# **Systematic Jitter Allocation & Eye Mask Definition**

John Petrilla,  
Avago Technologies  
January 2009

## Conclusions, Clause 86 Comments Summary

## With Observation Impairments - Reference

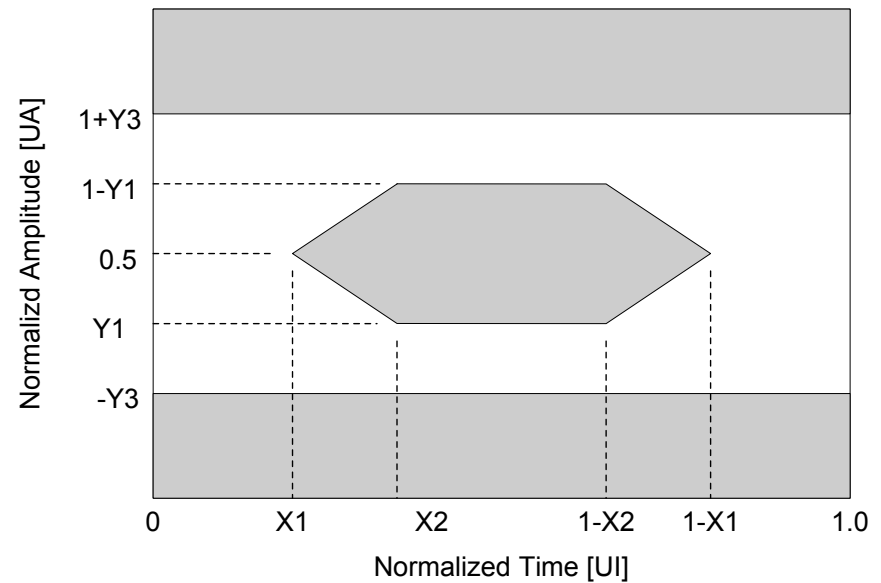
# Proposed value, 0.263 UI, does not fit the model which yields 0.248 UI when considering test artifacts.

## Expansion for lower hit ratio and D1.1 comparison

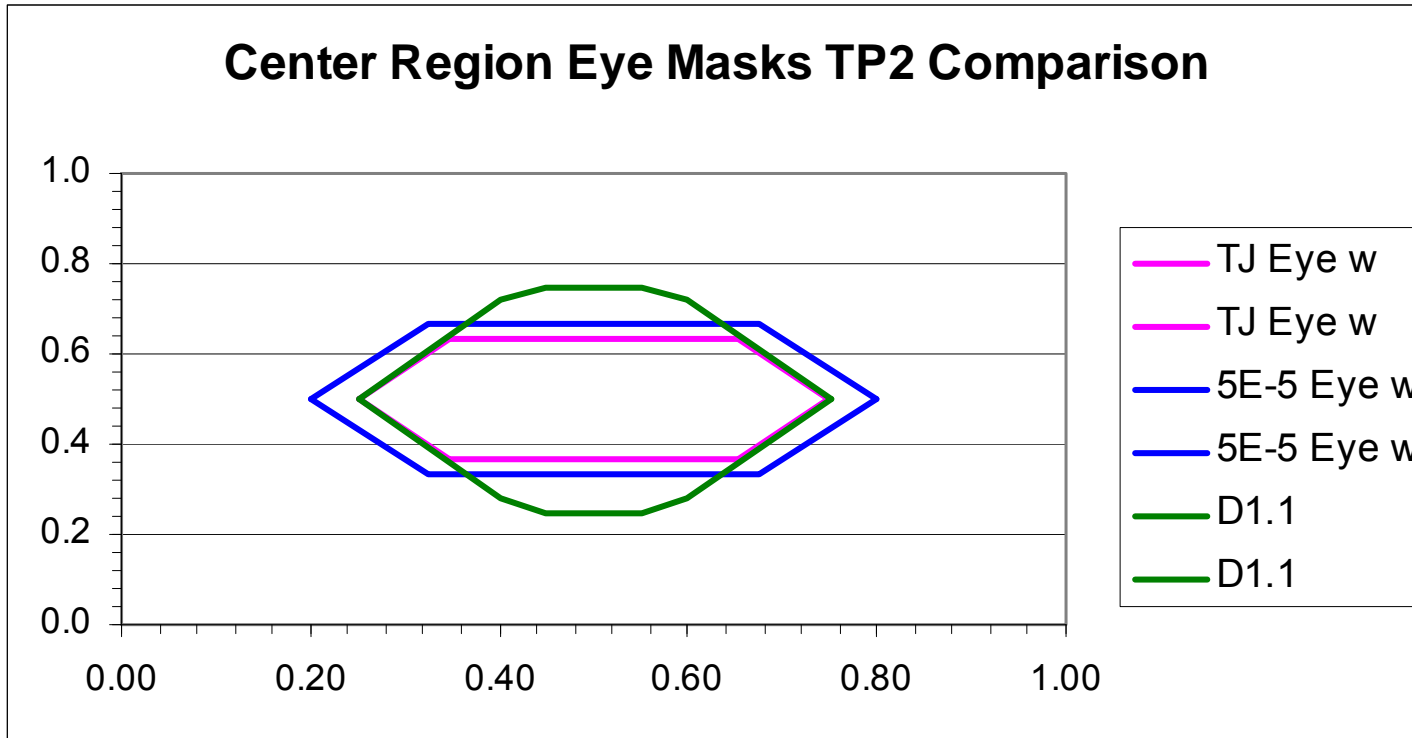
The D1.1 TP2 mask reuses the coordinates from clause 52 without consideration of differences between the applications. There is no consensus regarding the appropriate hit ratio and it appears designed around the expected capability of transmitters instead of the requirements of the downstream receiver. For example, 40GBASE-SR4 receivers are expected to provide 0.32 UI eye openings at TP4, while the D1.1 TP2 mask only offers a flat full-amplitude region of 0.10 UI.

## Consistency & balance among test points

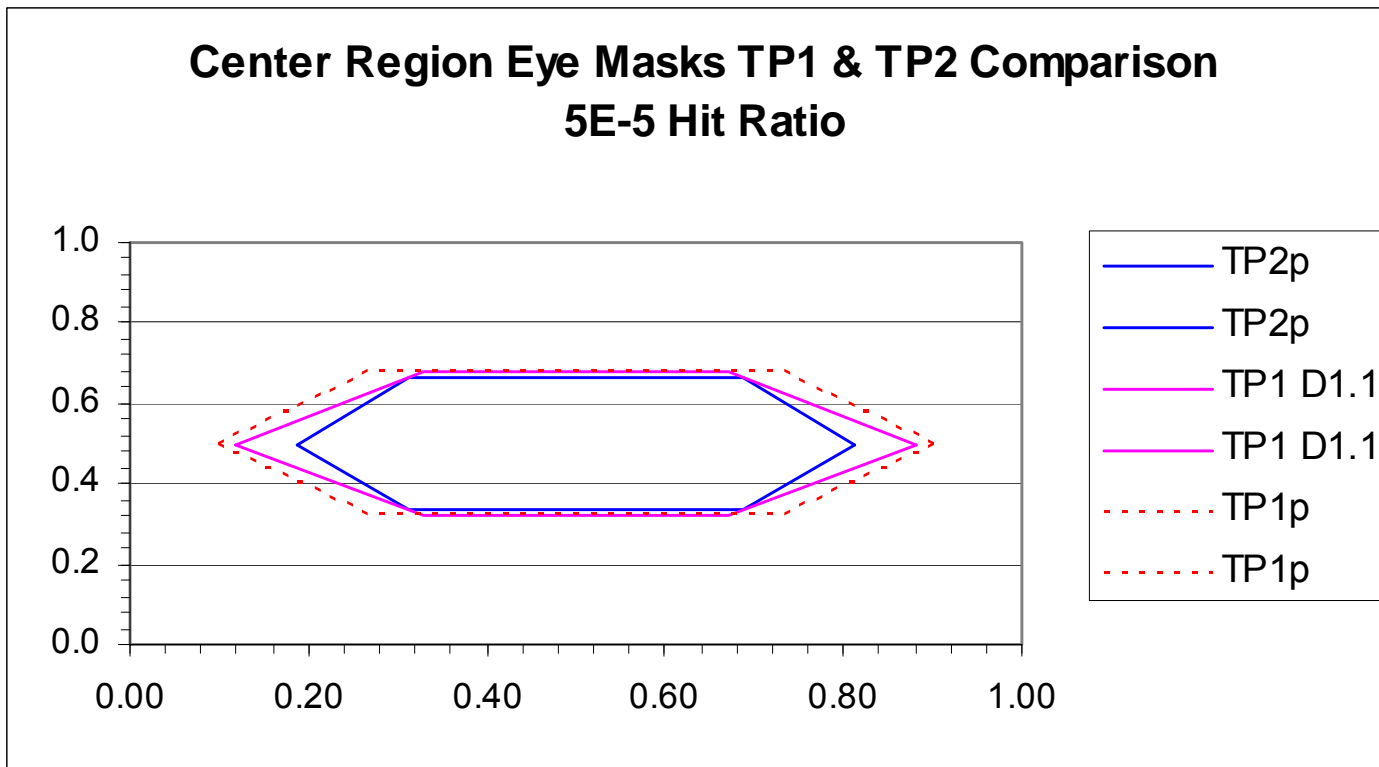
X1 and X2 values in D1.1 were taken from SFF-8431 without sufficient consideration that the PPI channel is more benign than SFI permitting a reduction in TP1 TJ (0.300 UI to 0.263 UI). To avoid a disproportionate burden on the optical Tx there should be reasonable margin between the X2 coordinates for TP1 and TP2 that define the minimum-height eye corners.
